MONROE COUNTY, NEW YORK

ADDENDUM NO. 3

**MONROE COMMUNITY COLLEGE
2011 WINDOW REPLACEMENT AND CONCRETE/BRICK REPAIR
DECEMBER 2010**

1 WEST ELEVATION - WINDOW REPLACEMENT & CONCRETE & BRICK REPAIR
SCALE: NOT TO SCALE

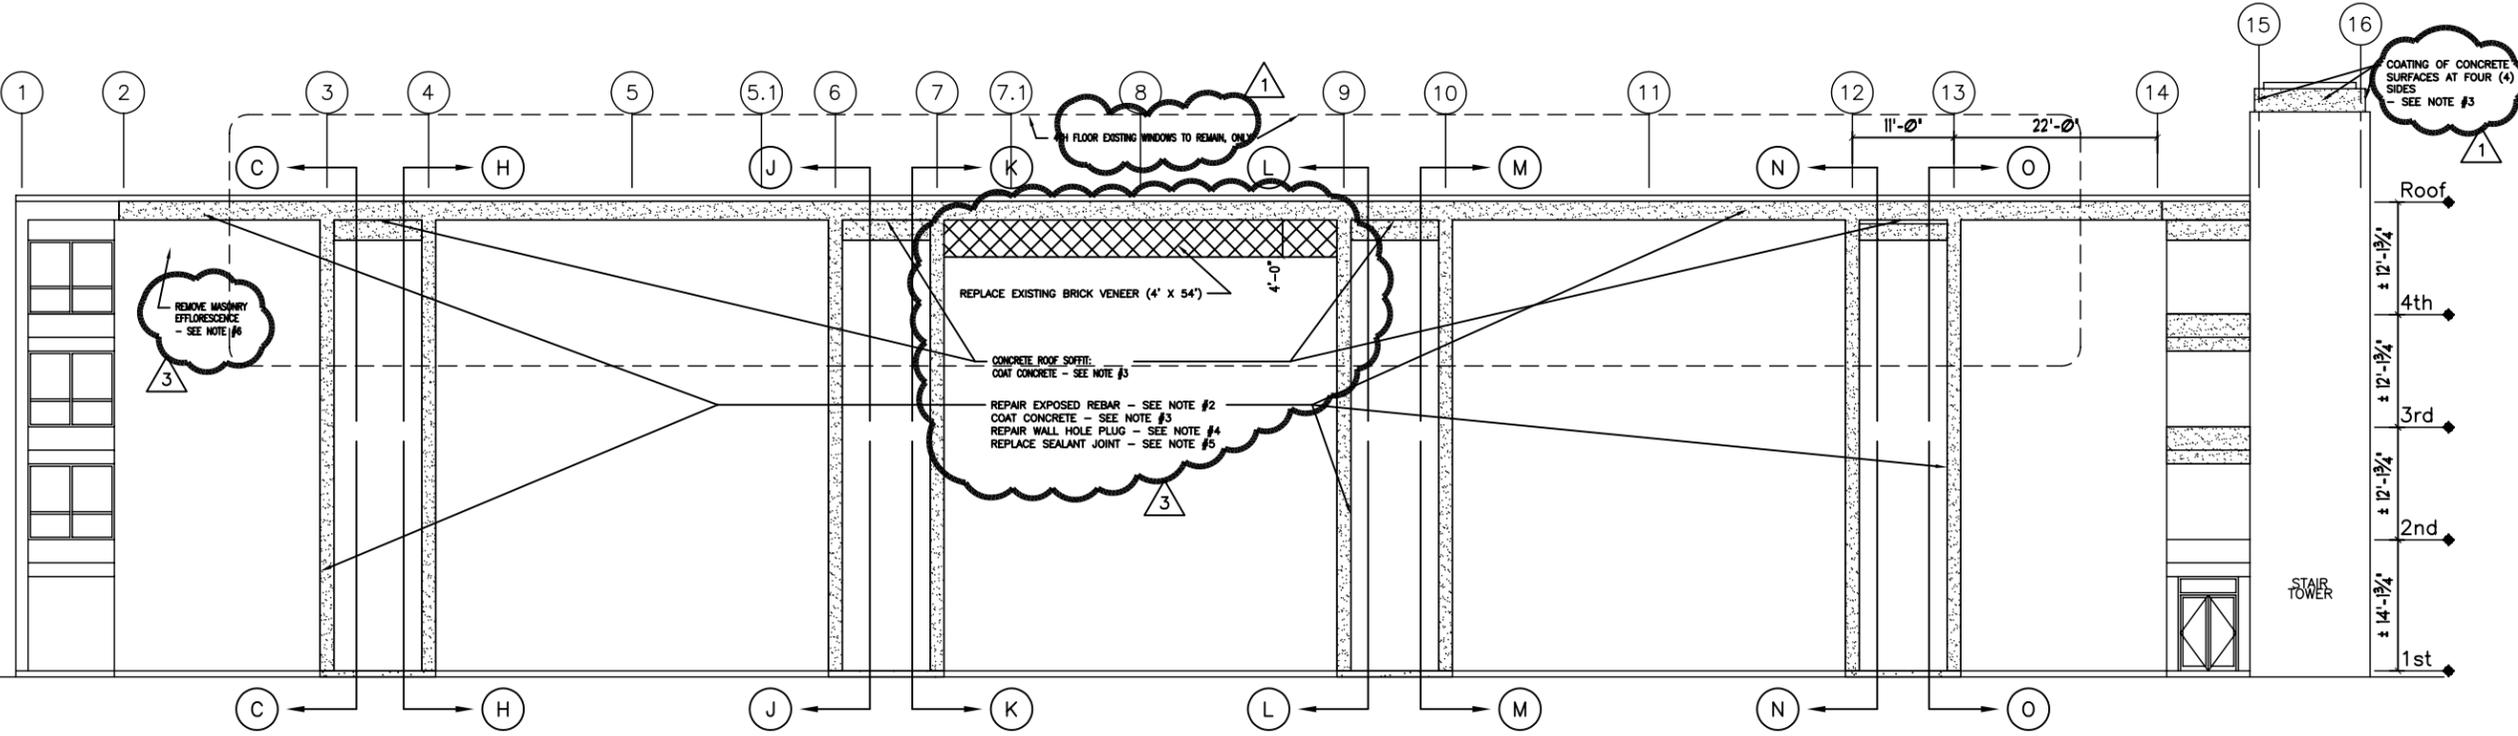
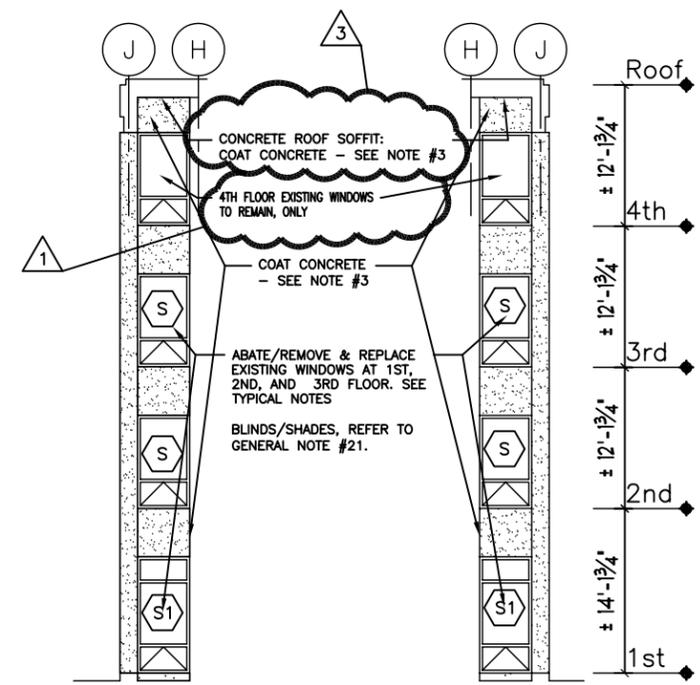
- 3-1 West Elevation – Window Replacement & Concrete & Brick Repair 1/A-204:
ADD: REPLACE WEST ELEVATION-WINDOW REPLACEMENT & CONCRETE & BRICK REPAIR 1/A-204 WITH ATTACHED WEST ELEVATION-WINDOW REPLACEMENT & CONCRETE & BRICK REPAIR, AS FOUND ON ADDENDUM 3, DRAWING 3-1.
NOTE:
THE SUMMERY OF CONCRETE & BRICK REPAIRS ON THE WEST ELEVATION 1/A-204 HAVE ALREADY BEEN TABULATED IN THE DIALOG BOX ON THIS DRAWING, AS NOTED BY ADDENDUMS.
- 3-2 South & North Elevations – Window Replacement Concrete & Brick Repair C, J, L, N, & H, K, M, O/A-204:
ADD: REPLACE NOTE between column lines H, PAINT SOFFIT NOTE #11 should read CONCRETE ROOF SOFFITS: COAT CONCRETE – SEE NOTE #3, as found on Addendum 3, Drawing 3-1.
- 3-3 Summery For Concrete & Brick Repair A-204:
DELETE: #11 PAINT SOFFIT – 192 SQ. FT in its entirety.
ADD: #11 NOT USED, as found on Addendum 3, Drawing 3-1.

NOTE:
THE SUMMARY OF CONCRETE & BRICK REPAIRS ON THE WEST ELEVATION 1/A-204 HAVE ALREADY BEEN TABULATED IN THE DIALOG BOX ON THIS DRAWING, AS NOTED BY ADDENDUMS.

#	WORK	QUANTITY
1	REPAIR SPALLED AND LOOSE CONCRETE	28 SQ.FT.
2	REPAIR CONCRETE AROUND EXPOSED REBAR	30 SQ.FT.
3	COATING OF CONCRETE SURFACE	3,064 SF
4	REPAIR WALL HOLE PLUG	101
5	RAKE AND INSTALL SEALANT JOINT	54 L.F.
6	MASONRY CLEANING OF EFFLORESCENCE AND STAINS	54 SQ.FT.
7	MASONRY REMOVAL AND REPLACEMENT OF BRICKS	2 SQ.FT.
8	MASONRY RAKE AND REPLACEMENT OF MORTAR JOINTS	216 SQ.FT.
9	MASONRY BRICK SHELF ANGLE REMOVAL & REPLACEMENT	-
10	MASONRY STRESS CRACK REPAIR	20 L.F.
11	NOT USED
